SUBJECT: RELOAD FOR CYCLE 8 OPERATION (TAC NO. 68878)

RE: PEACH BOTTOM ATOMIC POWER STATION, UNIT NO. 3

AMENDMENT TO FACILITY OPERATING LICENSE

Amendment No. 150
License No. DPR-56

APRM FLOW BIAS SCRAM RELATIONSHIP TO NORMAL OPERATING CONDITIONS
 FIGURE 1.1-1

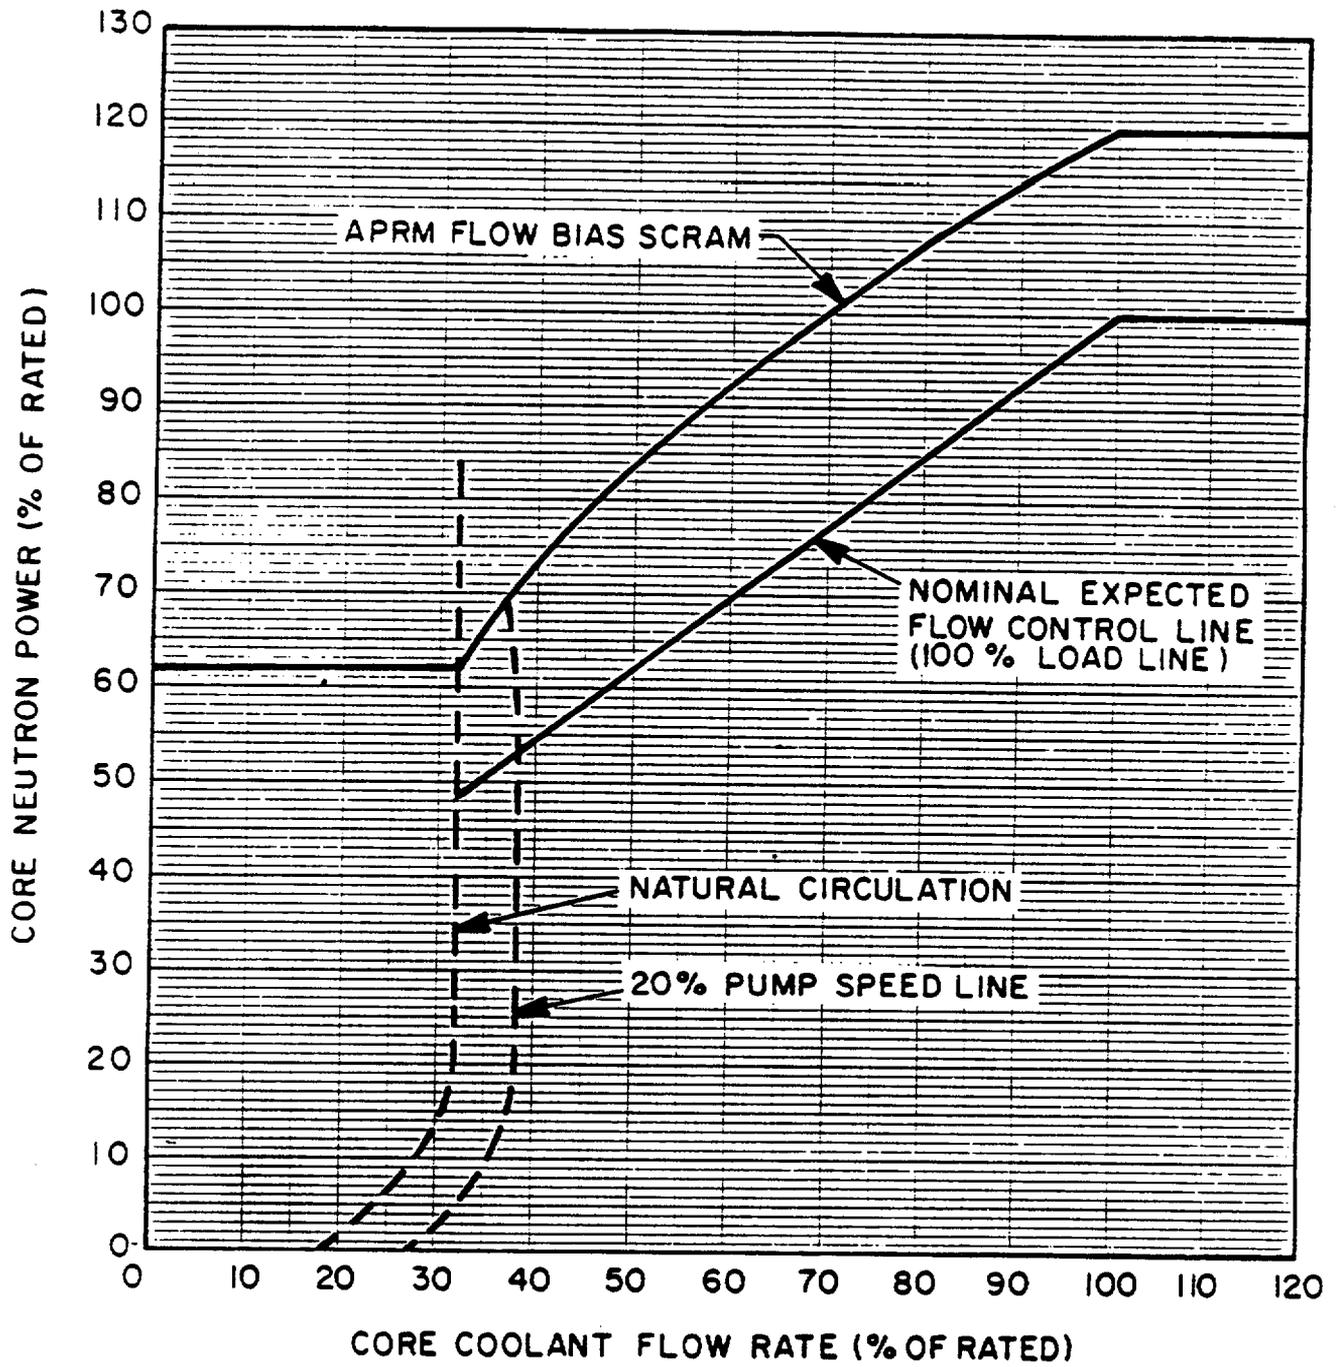
- (a) The new ELLLA APRM flow-biased scram and rod block setpoints. The changes are to TS 2.1.A.1, TS 2.1.B, Figure 1.1-1, Table 3.1-1, and Table 3.2.C and are acceptable.
- (b) The new MCPR limits for Cycle 8 and ICF operation. The changes are to TS 3/4.5.K, Tables 3.5.K.2 and 3.5.K.3, and Figures 3.5.K.1 and 3.5.K.2 and are acceptable.
- (c) The 14.4 KW/ft LHGR limit for the new GE8X8EB fuel. The changes are to TS 2.1.A, TS 2.1.B, TS 3.5.J, Table 3.1.1 and Table 3.2.C and are acceptable.
- (d) MAPLHGR limits for the new fuel. The changes are to TS 3.5.I, Figure 3.5.1.f and Figure 3.5.1.G and are acceptable.
